(c)CURRENT,INC.	MASTER STUDIO CUE SYSTEM SC8016	Mar.2005
H.ICHIHASHI	REPLACE FADER Instruction	SC8016 FAD replace

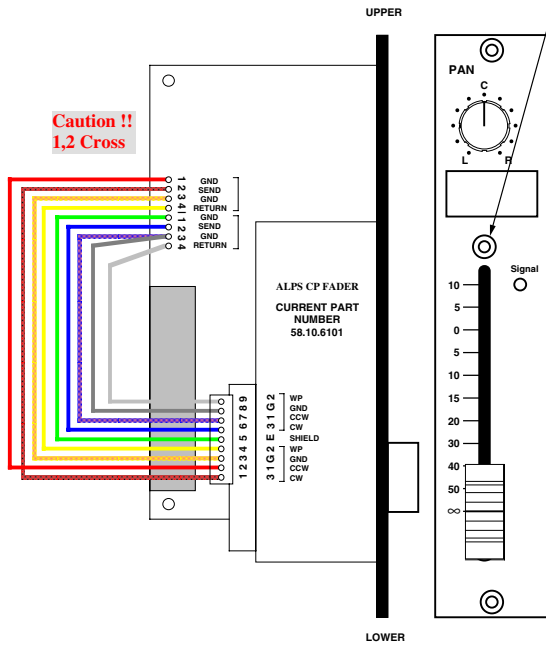
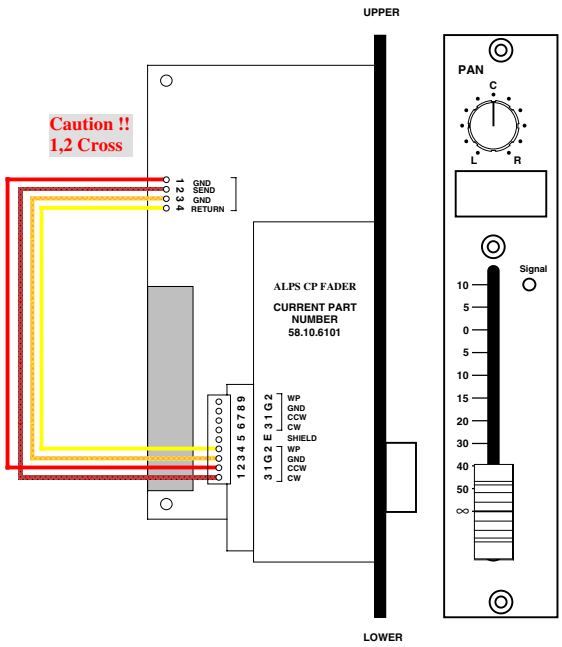
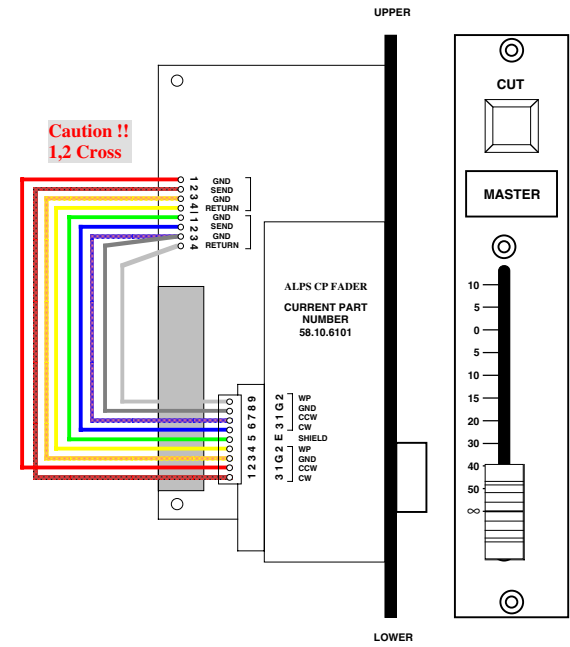
Expand fader mount hole to $\phi 3.2$ and expand countersink to $\phi 6.0$
